Appendix M

Homebuilder letters and maps regarding storm water concerns in platted subdivision

RE: Autumn Park Plat 2 drainage swales
PROJECT # 8630-06K.702

RE: Autumn Park Plat 3 drainage swales
PROJECT # 8630-06K.703

AUTUMN PARK PLAT 2
GRADING PLAN

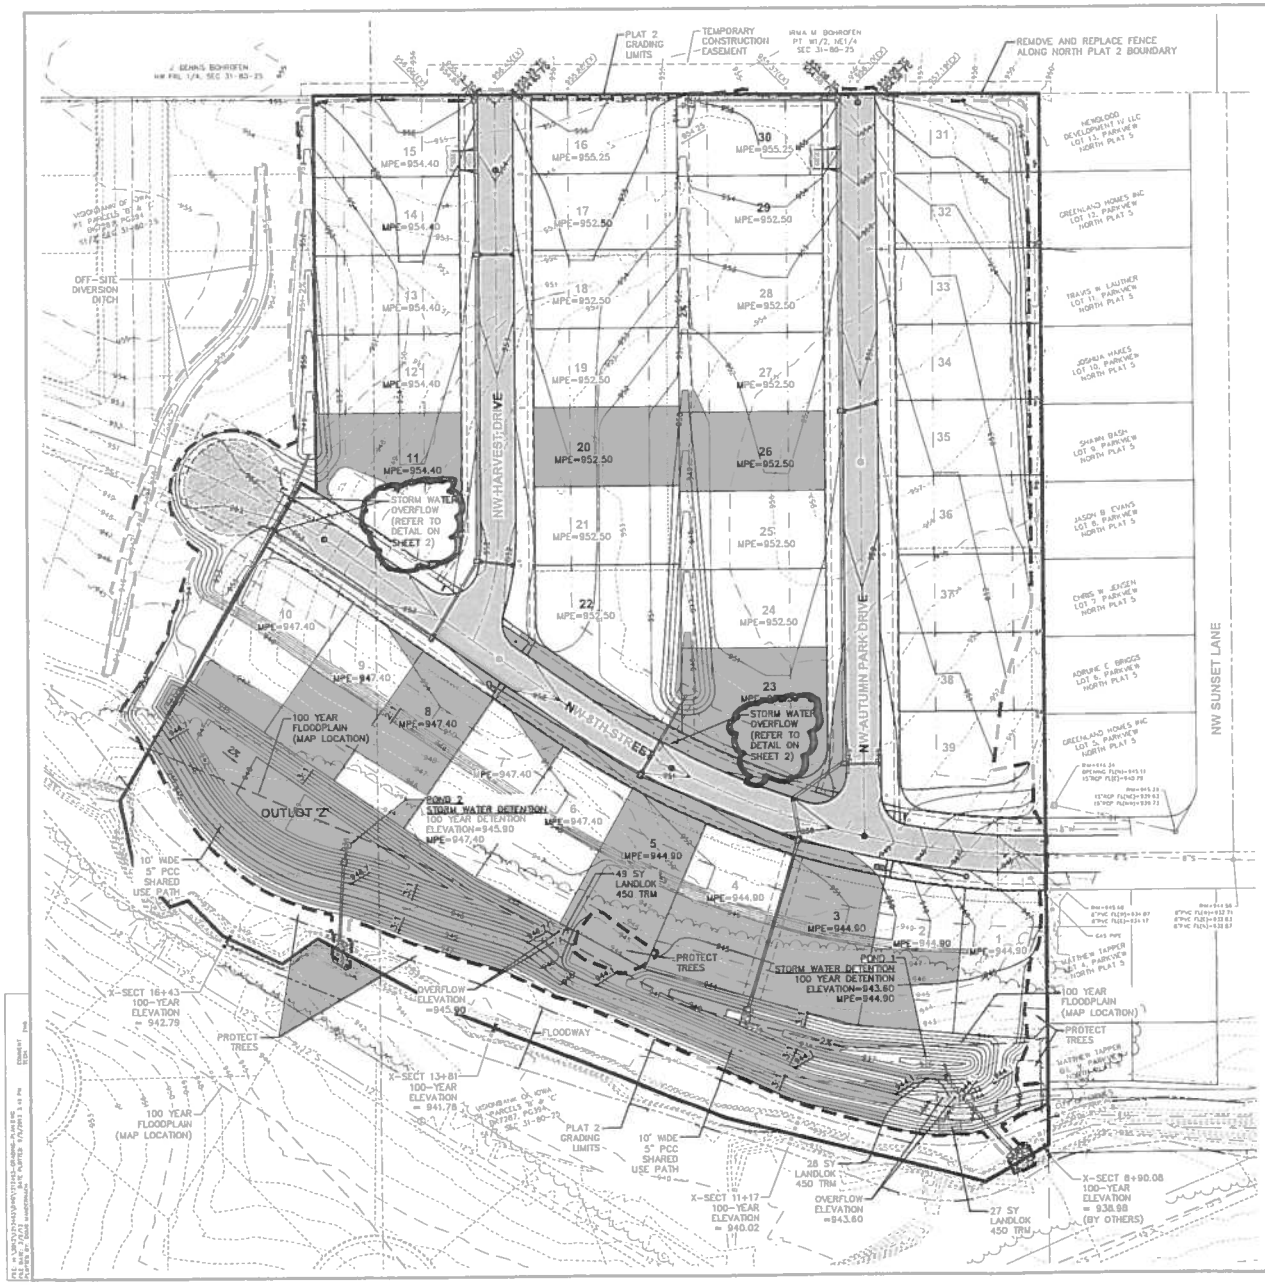
1. Stormwater emergency overflow spillway(s), please grade, and install PCC sidewalk, to the appropriate detail on plan sheet 2:
   a. lot 10 (**1000** NW **8th St.**)

b. lot 11 (**800** NW **Harvest Drive**)
   c. between lots 22 & 23 (**801** NW **Harvest Drive** & **800** NW **Autumn Park Drive**, respectively)
2. Stormwater flowage easement swale(s), please grade in accordance with details on plan sheets 2 & 6.

a. lot 10 (**1000** NW **8th St.**) – this is on the west side of the lot and flows south to the detention pond.
   b. between lots 16 & 30 (**909** NW **Harvest Dr.** & **908** NW **Autumn Park Dr.**, respectively) flows between lots to the south – ***5-foot*** *bottom minimum width, side slopes* ***4:1 (typical), 3:1 (maximum)****, minimum longitudinal slope is* ***2.0%****.*

c. between lots 17 & 29 (**905** NW **Harvest Dr.** & **904** NW **Autumn Park Dr.**, respectively) flows between lots to the south – ***5-foot*** *bottom minimum width, side slopes* ***4:1 (typical), 3:1 (maximum)****, minimum longitudinal slope is* ***2.0%****.*

d. between lots 18 & 28 (**901** NW **Harvest Dr.** & **900** NW **Autumn Park Dr.**, respectively) flows between lots to the south – ***5-foot*** *bottom minimum width, side slopes* ***4:1 (typical), 3:1 (maximum)****, minimum longitudinal slope is* ***2.0%.***

e. between lots 19 & 27 (**813** NW **Harvest Dr.** & **816** NW **Autumn Park Dr.**, respectively) flows between lots to the south – ***5-foot*** *bottom minimum width, side slopes* ***4:1 (typical), 3:1 (maximum)****, minimum longitudinal slope is* ***2.0%.***

f. between lots 20 & 26 (**809** NW **Harvest Dr.** & **812** NW **Autumn Park Dr.**, respectively) flows between lots to the south – ***5-foot*** *bottom minimum width, side slopes* ***4:1 (typical), 3:1 (maximum)****, minimum longitudinal slope is* ***2.0%.***

g. between lots 21 & 25 (**805** NW **Harvest Dr.** & **808** NW **Autumn Park Dr.**, respectively) flows between lots to the south – ***5-foot*** *bottom minimum width, side slopes* ***4:1 (typical), 3:1 (maximum)****, minimum longitudinal slope is* ***2.0%.***

h. between lots 22 & 24 (**801** NW **Harvest Dr.** & **804** NW **Autumn Park Dr.**, respectively) flows between lots to the south – ***5-foot*** *bottom minimum width, side slopes* ***4:1 (typical), 3:1 (maximum)****, minimum longitudinal slope is* ***2.0%.***

i. between lots 22 & 23 (**801** NW **Harvest Dr.** & **800** NW **Autumn Park Dr.**, respectively) flows between lots to the south – ***5-foot*** *bottom minimum width, side slopes* ***4:1 (typical), 3:1 (maximum)****, minimum longitudinal slope is* ***2.0%.***

TYPICAL SECTIONS AND DETAILS

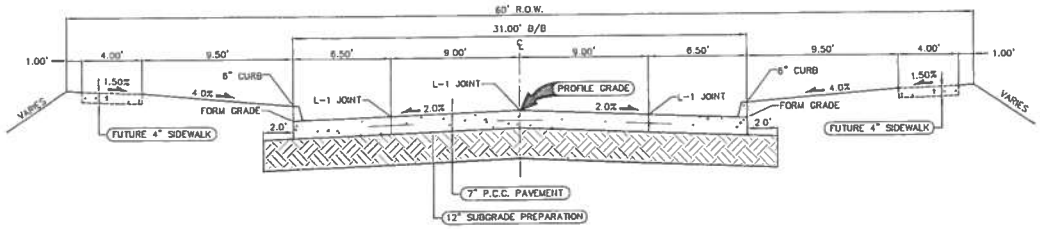
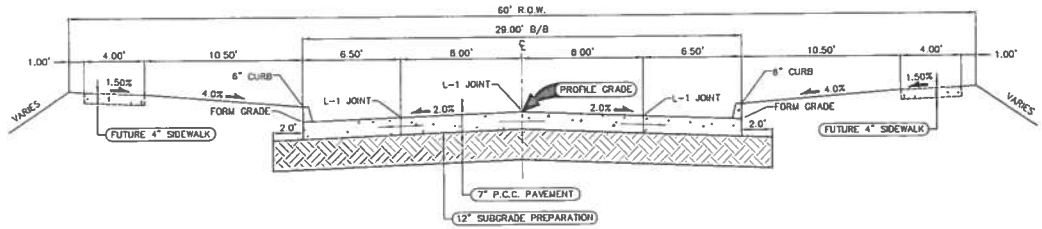
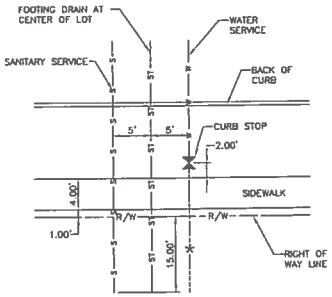
An item the homebuilder might easily overlook is how the sidewalk needs to be graded at the overflow sites. Sidewalk slopes away from the street (reverse of normal).

TYPICAL RIGHT OF WAY GRADING AT STORM WATER OVERFLOW POINTS

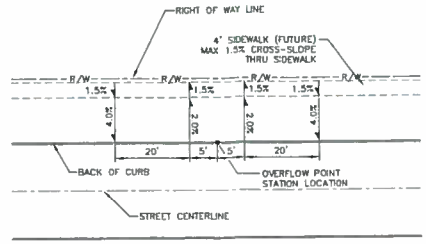
An item the homebuilder might easily overlook is how the sidewalk needs to be graded at the overflow sites. Sidewalk slopes away from the street (reverse of normal).

1. Stormwater emergency overflow spillway(s), please grade to the appropriate details on plan sheet 3:
   a. **NW Brookside Dr.** – station 11+14, this is on the east (right) side of the roadway and overflows to the detention pond for Plat 1.

b. between lots 11 & 12 (**916** & **1000** NW **5th St.,** respectively)
   c. between lots 27 & 28 (**616** & **613** NW **Harvest Court,** respectively)

d. between lots 35 & 36 (**512** & **513** NW **Autumn Park Court**, respectively)
   e. between lots 46 & 47 (**608** & **601** NW **Sunset Court,** respectively)

AUTUMN PARK PLAT 3
GRADING PLAN

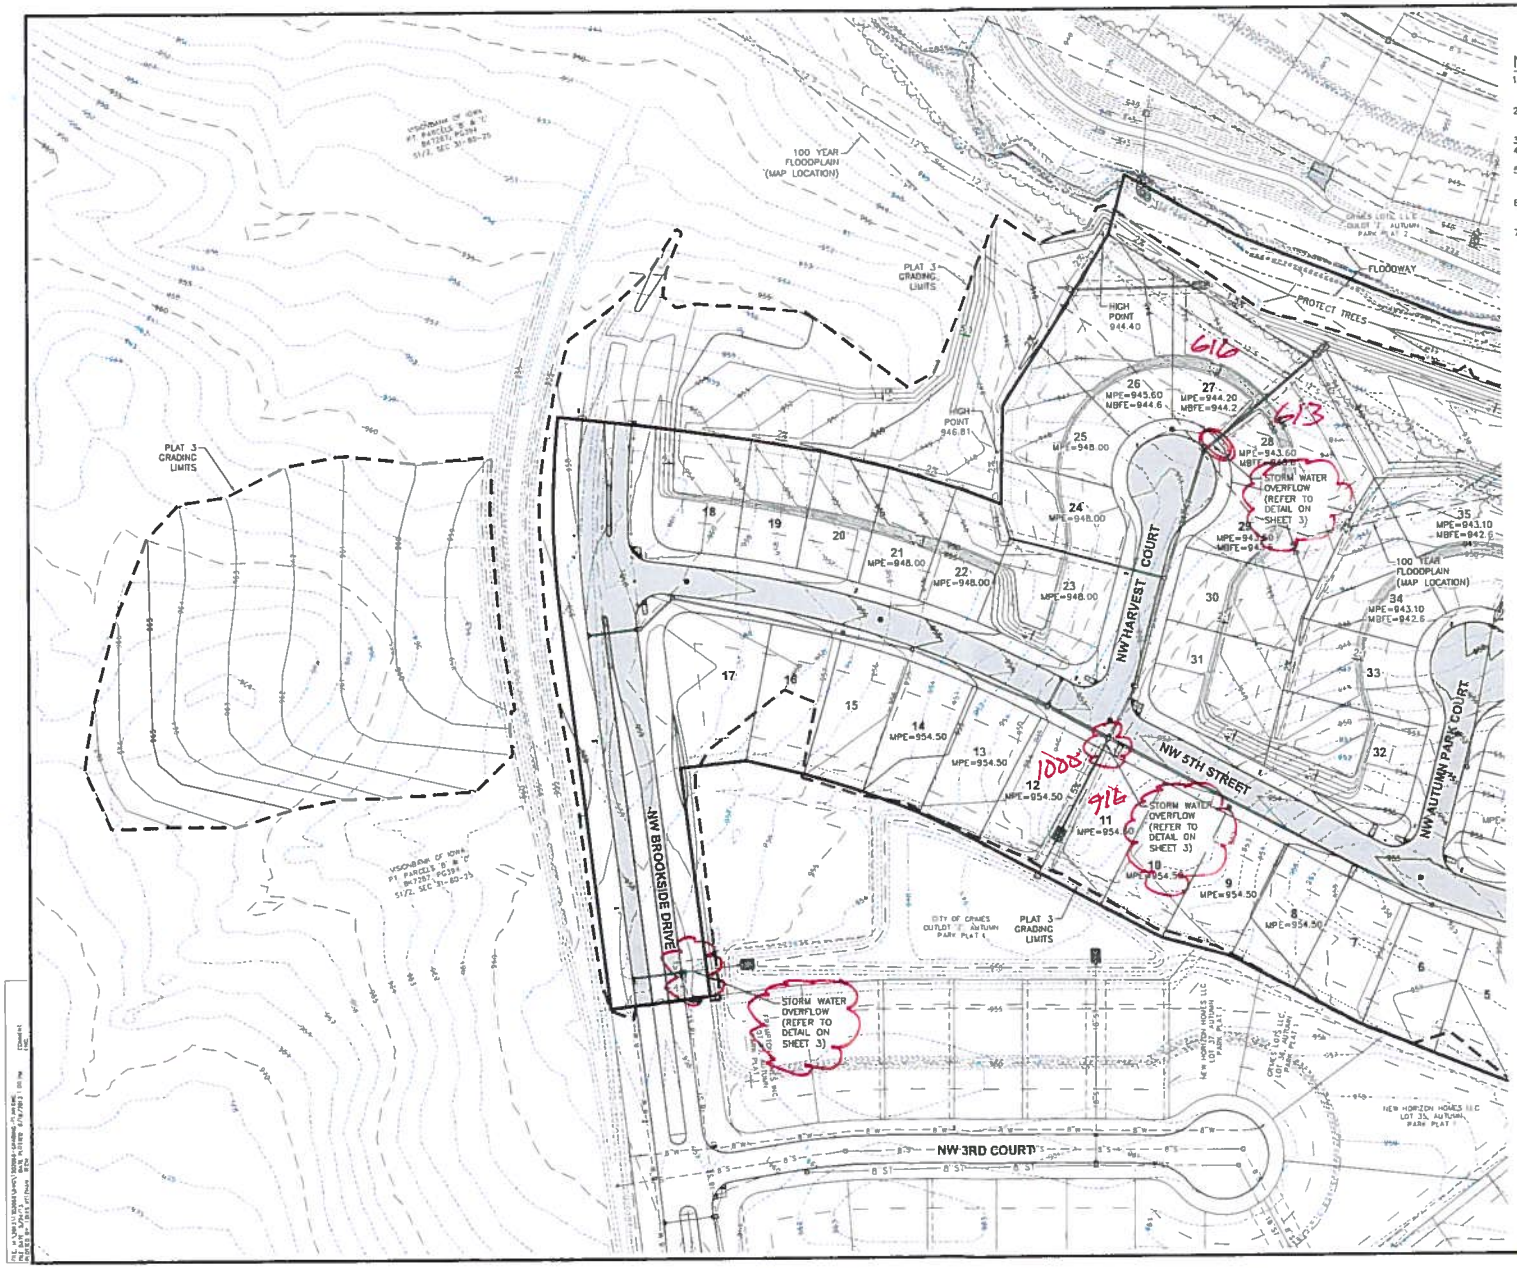
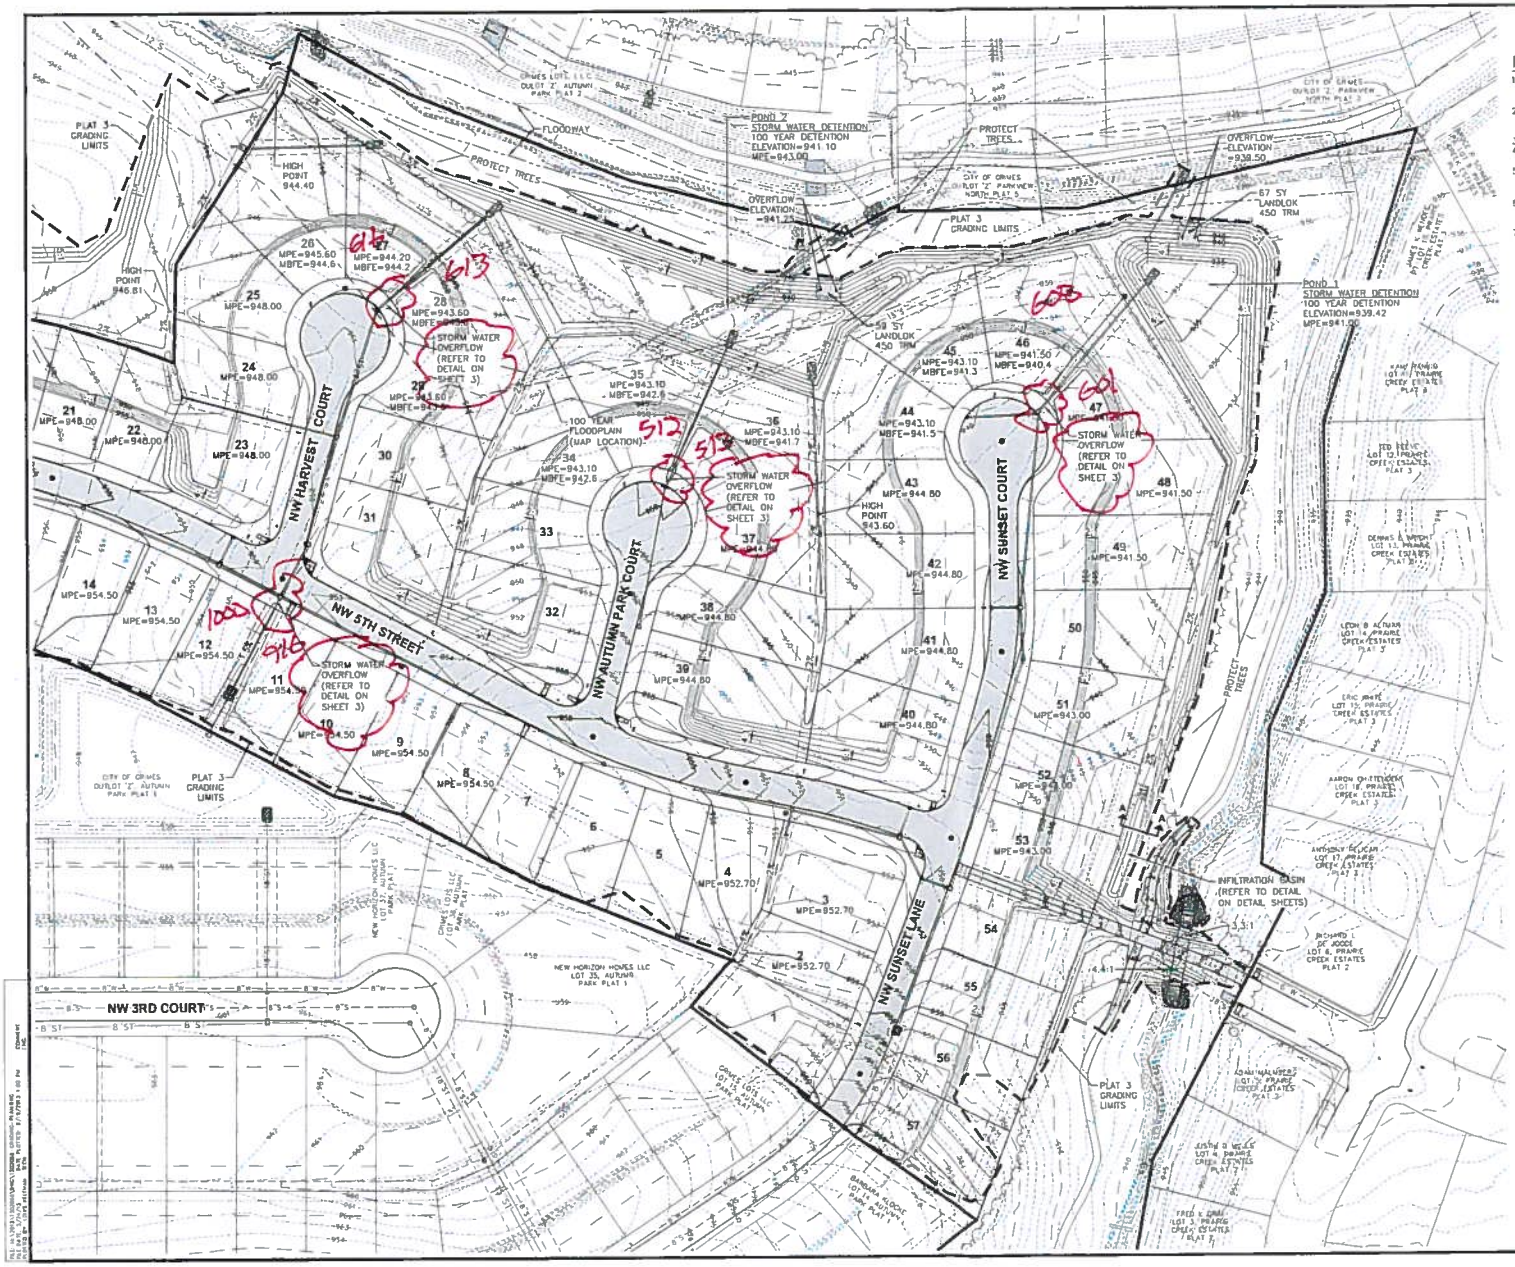
2. Stormwater flowage easement swale(s), please grade in accordance with details on plan sheets 4, 7 & 8.
   a. **NW Brookside Dr.** – station 11+14, this is on the east (right) side of the roadway and overflows to the detention pond for Plat 1.

b. between lots 27 & 28 (**616** & **613** NW **Harvest Ct.,** respectively) flows between lots to the NE – ***2-foot*** *bottom minimum width, side slopes* ***4:1 (typical), 3:1 (maximum),*** *minimum longitudinal slope to drain.*

c. between lots 11 & 12 (**916** & **1000** NW **5th St.,** respectively) flows between the lots to the south – ***2-foot*** *bottom minimum width, side slopes* ***4:1 (typical), 3:1 (maximum),*** *minimum longitudinal slope is* ***1.50%.***

d. between lots 4 & 2 (**800** NW **5th St.** & **405** NW **Sunset Ln.,** respectively) flows between lots to the north – ***2-foot*** *bottom minimum width, side slopes* ***4:1 (typical), 3:1 (maximum),*** *minimum longitudinal slope is* ***4.0%.***

e. between lots 4 & 3 (**800** NW **5th St.** & **409** NW **Sunset Ln.**, respectively) flows between lots to the north – ***2-foot*** *bottom minimum width, side slopes* ***4:1 (typical), 3:1 (maximum)****, minimum longitudinal slope is* ***2.0%.***

f. between lots 28 & 34 (**613** NW **Harvest Ct.** & **508** NW **Autumn Park Ct.**, respectively) flows between lots to the north – ***2-foot*** *bottom minimum width, side slopes* ***4:1 (typical), 3:1 (maximum)****, minimum longitudinal slope is* ***2.0%.***

g. between lots 29 & 34 (**609** NW **Harvest Ct.** & **508** NW **Autumn Park Ct.**, respectively) flows between lots to the north – ***2-foot*** *bottom minimum width, side slopes* ***4:1 (typical), 3:1 (maximum)****, minimum longitudinal slope is* ***2.0%.***

h. between lots 30 & 33 (**605** NW **Harvest Ct.** & **504** NW **Autumn Park Ct.**, respectively) flows between lots to the north – ***2-foot*** *bottom minimum width, side slopes* ***4:1 (typical), 3:1 (maximum)****, minimum longitudinal slope is* ***2.0%.***

i. between lots 31 & 32 (**601** NW **Harvest Ct.** & **500** NW **Autumn Park Ct.**, respectively) flows between lots to the north – ***2-foot*** *bottom minimum width, side slopes* ***4:1 (typical), 3:1 (maximum)****, minimum longitudinal slope is* ***2.0%.***

j. between lots 39 & 40 (**501** NW **Autumn Park Ct.** & **500** NW **Sunset Ct.**, respectively) flows between lots to the north – ***2-foot*** *bottom minimum width, side slopes* ***4:1 (typical), 3:1 (maximum)****, minimum longitudinal slope is* ***2.0%.***

k. between lots 38 & 41 (**505** NW **Autumn Park Ct.** & **504** NW **Sunset Ct.**, respectively) flows between lots to the north – ***2-foot*** *bottom minimum width, side slopes* ***4:1 (typical), 3:1 (maximum)****, minimum longitudinal slope is* ***2.0%.***

l. between lots 37 & 42 (**509** NW **Autumn Park Ct.** & **508** NW **Sunset Ct.**, respectively) flows between lots to the north – ***2-foot*** *bottom minimum width, side slopes* ***4:1 (typical), 3:1 (maximum)****, minimum longitudinal slope is* ***2.0%.***

m. between lots 37 & 43 (**509** NW **Autumn Park Ct.** & **512** NW **Sunset Ct.**, respectively) flows between lots to the north – ***2-foot*** *bottom minimum width, side slopes* ***4:1 (typical), 3:1 (maximum)****, minimum longitudinal slope is* ***2.0%.***

n. between lots 36 & 44 (**513** NW **Autumn Park Ct.** & **600** NW **Sunset Ct.**, respectively) flows between lots to the north – ***2-foot*** *bottom minimum width, side slopes* ***4:1 (typical), 3:1 (maximum)****, minimum longitudinal slope is* ***2.0%.***

o. Lots 53-48 (NW **Sunset Ct.**), east side – ***2-foot*** *minimum bottom width, side slopes* ***4:1 (typical), 3:1 (maximum)****, minimum longitudinal slope is* ***2.0%.*** ***NOTE: this swale is east of the property line and should not be disturbed by the homebuilder.***

REFERENCE NUMBER	030001 040577 070084
DRAWN BY:	JMR
CHECKED BY:	DB
REVISION DATE:	2-7-13 2ND C 3-4-13 3RD C 3-15-13 FINAL
PROJECT NUMBER:	12006
SHEET NUMBER:	C2.4

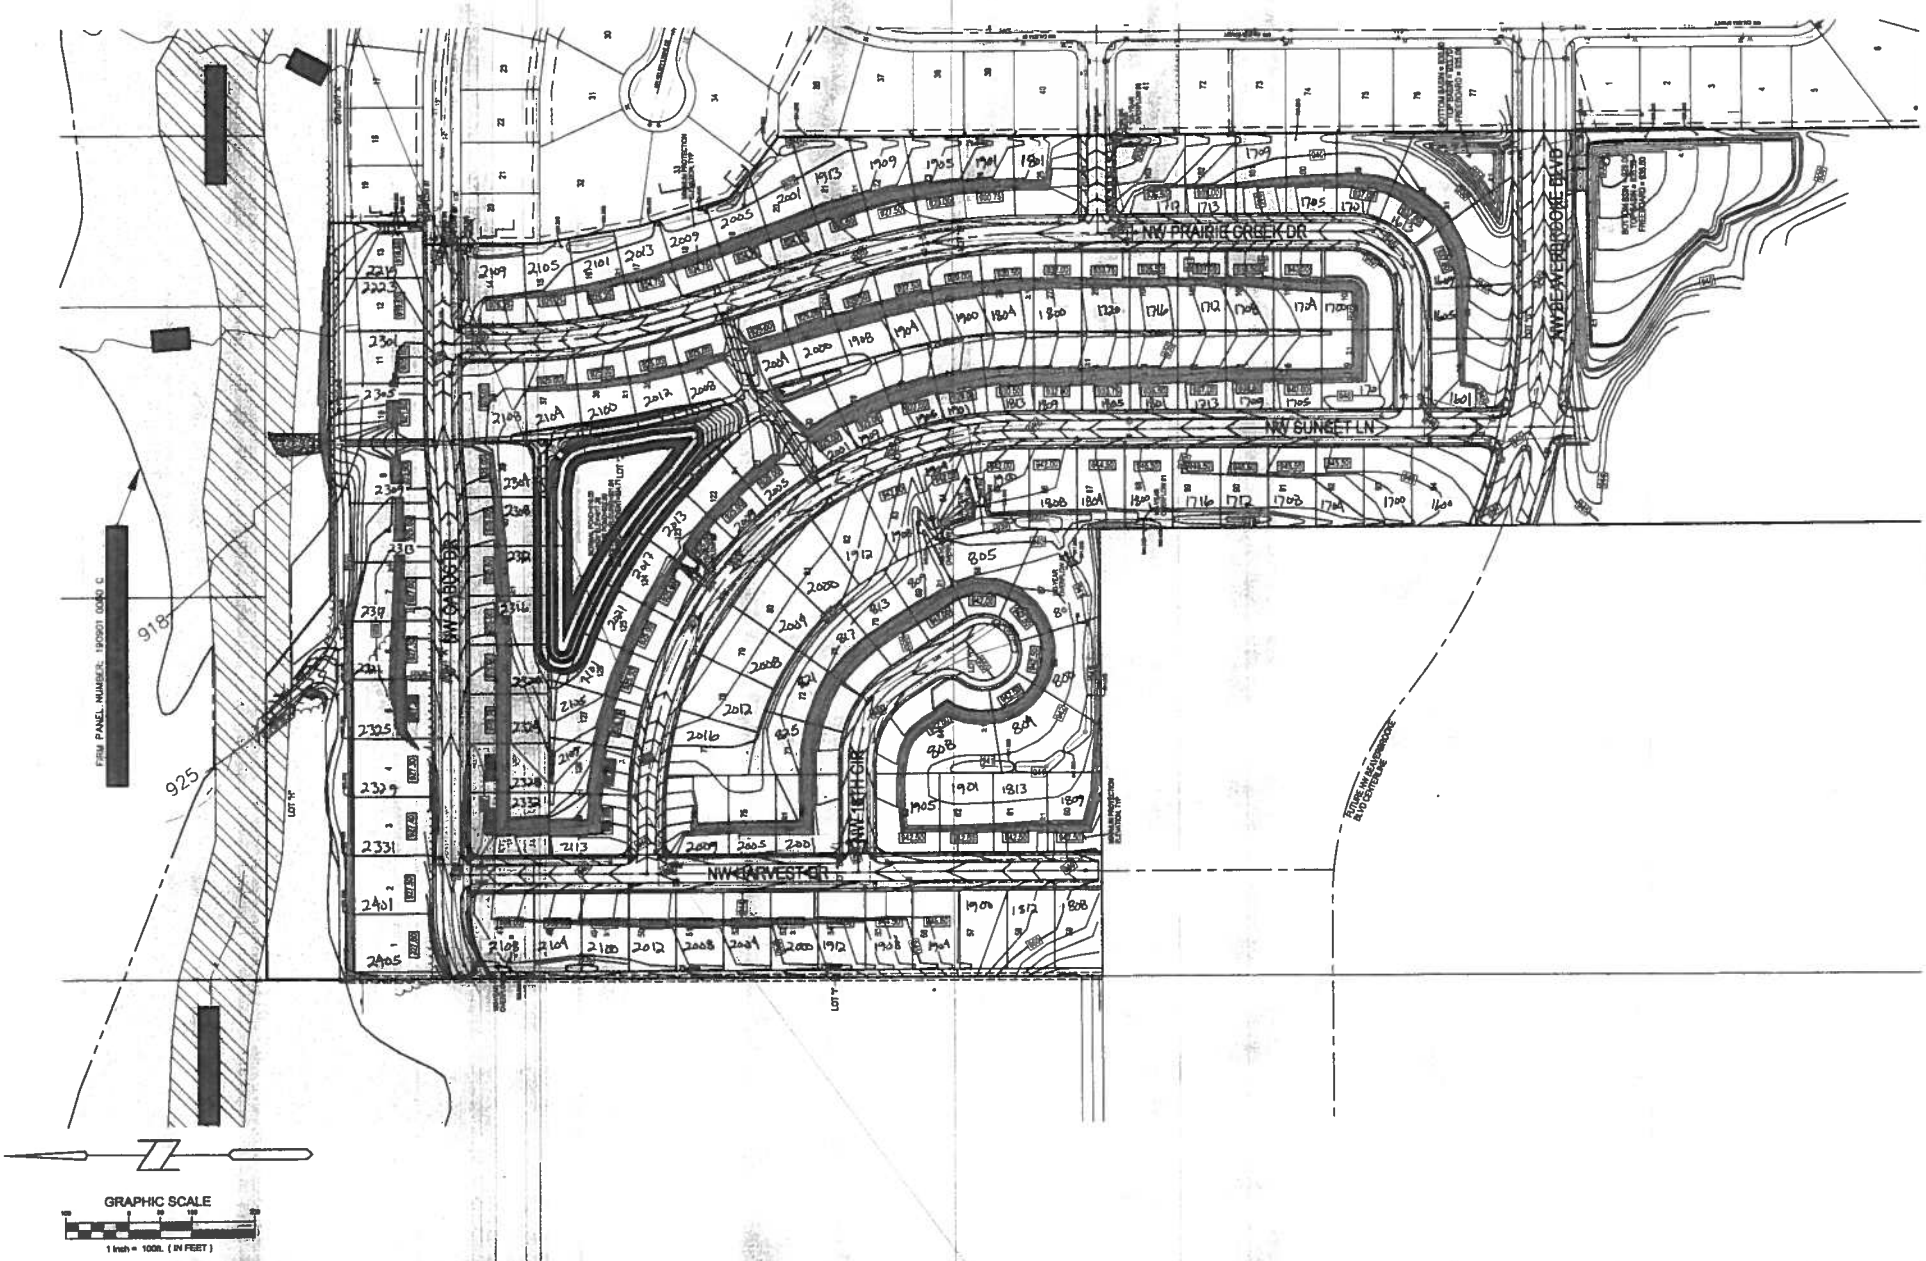
The attached plan sheets (C2.4 – Grading & C7.1 – details) from the approved construction drawings show how the site is to be graded. The below information is from those plan sheets and has had street address information added to assist with locating the swales and overflow spillways.

Something to be especially aware of is the 20-foot wide drainage swale along the north side of lot 123. This could make it rather difficult for the homebuilder to "site" the house within the lot.

1. Stormwater emergency overflow spillway(s), please grade to the appropriate details on plan sheets C2.4 & C7.1:
    a. Pond in lot 98 (***1613 Prairie Creek Dr.***) – ***10-foot*** *bottom width, side slope* ***4:1****, elevation* ***933.70*** *– SE corner of lot* ***overflows trail*** *onto NW Beaverbrooke Blvd.*

2. Stormwater flowage easement swale(s), please grade in accordance with details on plan sheets C2.4 & C7.1:
    a. Lots 21-25, **Prairie Ck. Dr.**, east side – ***5-foot*** *bottom width, side slope* ***4:1****, minimum longitudinal slope is* ***2.0%****.*

EMERGENCY SPILLWAY DETAIL

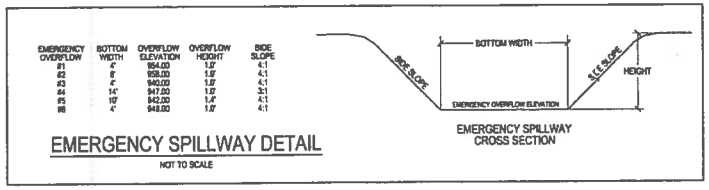
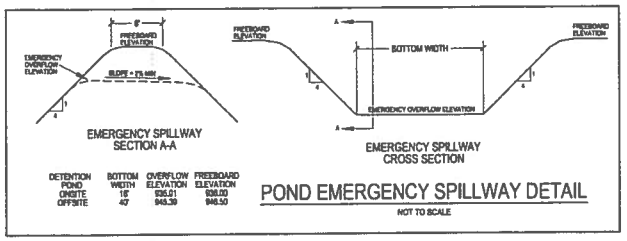
1. Stormwater emergency overflow spillway(s), please grade to the appropriate details on plan sheets C2.1 & C6.1:
   a. Pond in lot 58 (**1512 NW Sunset Ln.**) – ***40-foot*** *bottom width, elevation* ***945.39*** – *NE corner of lot overflows sidewalk onto NW Beaverbrooke Blvd.*
